Access Compliance Report Public Rights-of-Way (Curb Ramps)

Main Street: SIENNA_PKWY Cross Street: COVENANT_HILLS_DR Location: NE

ADA ID: RPRK220223171809 Ramp Type: Type 4 - Parallel Initial Pass/Fail: Fail Overall Compliance: No Severity Score: 2

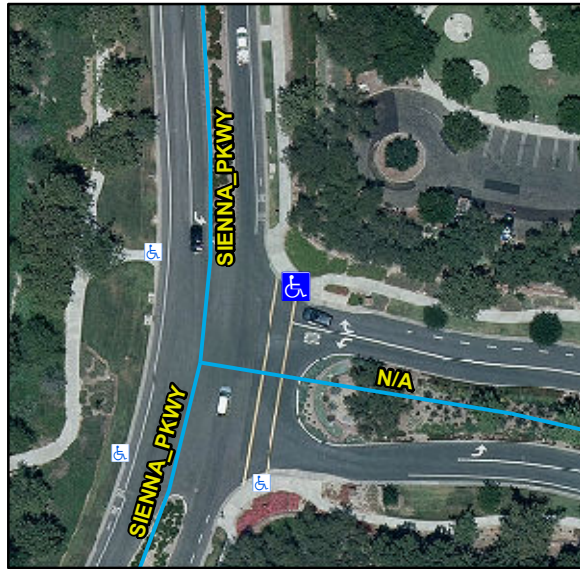
Compliance	Description	Data	Compliance	Description	Data
N/A	Ramp Length LT (in)	128	N/A	Ramp Length RT (in)	135
Yes	Ramp Width LT (in)	89	Yes	Ramp Width RT (in)	89
Yes	Ramp Run Slope LT (%)	6.8	Yes	Ramp Run Slope RT (%)	2.4
No	Ramp Cross Slope LT (%)	3.8	No	Ramp Cross Slope RT (%)	2.1
N/A	Landing Present	N/A	N/A	DWS Provided	N/A
N/A	Landing Length (in)	N/A	N/A	DWS Contrast	N/A
N/A	Landing Width (in)	N/A	N/A	DWS Length (in)	N/A
N/A	Landing Run Slope (%)	N/A	N/A	DWS Full Width	N/A
N/A	Landing Cross Slope (%)	N/A		DWS Offset Type	N/A
N/A	Landing Movement Obstructed?	N/A	N/A	DWS Offset Left (in)	N/A
	Landing Movement Type	N/A	N/A	DWS Offset Right (in)	N/A
N/A	Landing Shared	N/A			
N/A	Clear Space	Yes			
N/A	Clear Space To Crosswalk (in)	48			
N/A	Marked Crosswalk 1	No	N/A	Marked Crosswalk 2	Yes
	Crossing 1 Direction	W		Crossing 2 Direction	S
	Marked Crosswalk 1 Width (in)	N/A		Marked Crosswalk 2 Width (in)	144

N/A	Ramp Inside Crosswalk 1	N/A	N/A	Ramp Inside Crosswalk 2	No
	Crossing 1 Slope (%)	2.6		Crossing 2 Slope (%)	3.6
	Crossing 1 Cross Slope (%)	3.6		Crossing 2 Cross Slope (%)	1.6
N/A	Gutter Ponding	N/A	N/A	Curb Slope	1.4
Yes	Gutter Lip Height (in)	0		Road Run Slope (%)	0.5
N/A	Gutter Run Slope (%)	N/A		Road Cross Slope (%)	1.8
N/A	Gutter Cross Slope (%)	N/A	Yes	Perpendicular Joint Present	Yes
Yes	Overall Surface Condition	Acceptable			
	Cross Gutter Present?	No		Spandrel Present?	No
	Replace Cross Gutter?	N/A		Replace Spandrel?	N/A

Remove & Replace Curb Ramp With Two New Directional Ramps or Equivalent. Restripe Crosswalk.

R304.5.3, STD 1115
